FINAL PLAT OF
"BLUESTEM ACRES SECOND ADDITION"
SEDGWICK COUNTY, KANSAS
IN THE SW 1/4 OF SECTION 9, T26S, R3W OF THE 6TH P.M.

RE: SUB 2001-47 -- Final Plat of Bluestem Acres Addition

At the regular meeting of the Subdivision Committee of the Metropolitan Area Planning Commission on Thursday, August 30, 2001, the above captioned plat was considered. The action of the Committee was to approve the final plat, subject to the following:

CASE NUMBER: SUB 2001-47 -- BLUESTEM ACRES SECOND ADDITION

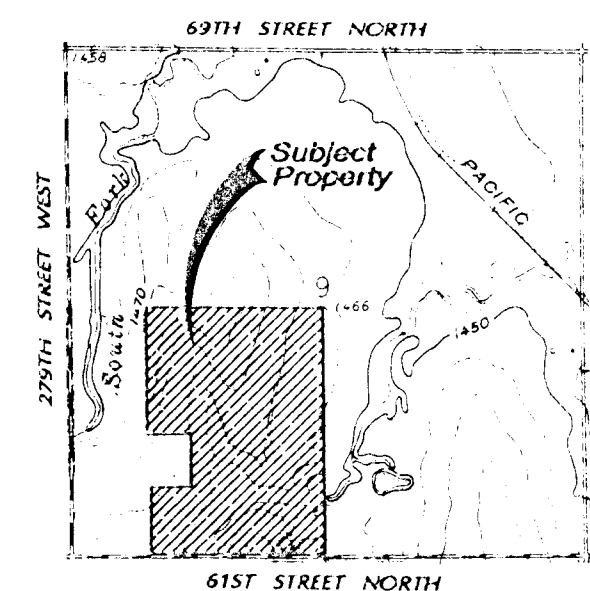
- C. **County Engineering** needs to comment on the status of the applicant's drainage plan. A floodway reserve is needed in Lots 1 through 5, 13 and 14, Block 2, and in Lots 2, 3, and 4 of Block 1. **A lot grading plan is needed.**

- E. The Applicant proposes a 70-ft contingent dedication of street right-of-way extending to the east line of the plat in order to provide potential street connection to adjoining properties. On the final plat, the contingent dedication of right-of-way needs to be referenced in the plat's text as

becoming effective "upon the platting of any adjacent subdivision having a street connecting thereto". The dedication should be labeled as a "contingent street dedication".

- G. The County Fire Department/GIS needs to comment on recommendations for the plat's street names. *Busy Bee Court shall be labeled "Busy Bee Ct".*

- H. The pipeline easement agreements appear to indicate a 25-ft pipeline setback. This setback shall be indicated on the face of the plat and labeled as a Koch Pipeline Setback."

The 30-ft easements have been platted as requested.
